SERVICE LETTER

No. 665A

Rotator Type Intake Valves -- reference Lycoming Service Instruction No. 1280A dated September 28, 1973, reproduced on reverse side.

Service Instruction No. 1280A
(Supersedes Service Instruction No. 1280)
Engineering Aspects are
FAA (DEER) Approved

Rotator Intake Valve Components

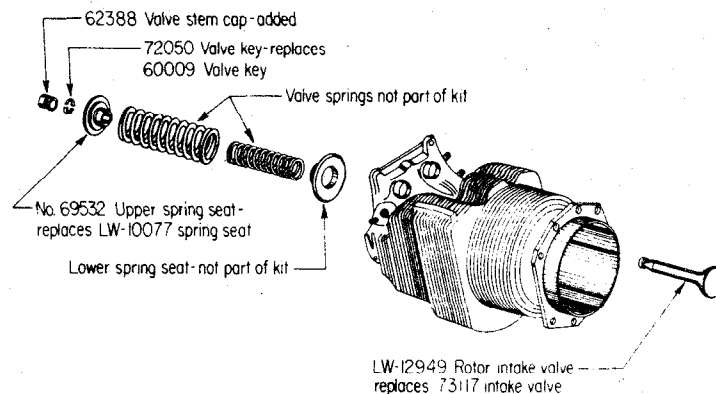
In order to improve valve seating and minimize compression loss at the intake valve seat, a new intake valve, incorporating a rotator cap is available for installation in applicable aircraft engines now in service. This rotator valve, LW-12949 and its associated parts replace the conventional intake valve, 73117 that has been used in these engines.

1 no. LW-12949	Intake Valve (replaces 73117 intake valve)
1 no. 69532	Upper Spring Seat (replaces LW-10077 spring seat)
2 no. 72050	Valve Key (replaces 60009 valve key)
1 no. 62388	Valve Stem Cap (added part)
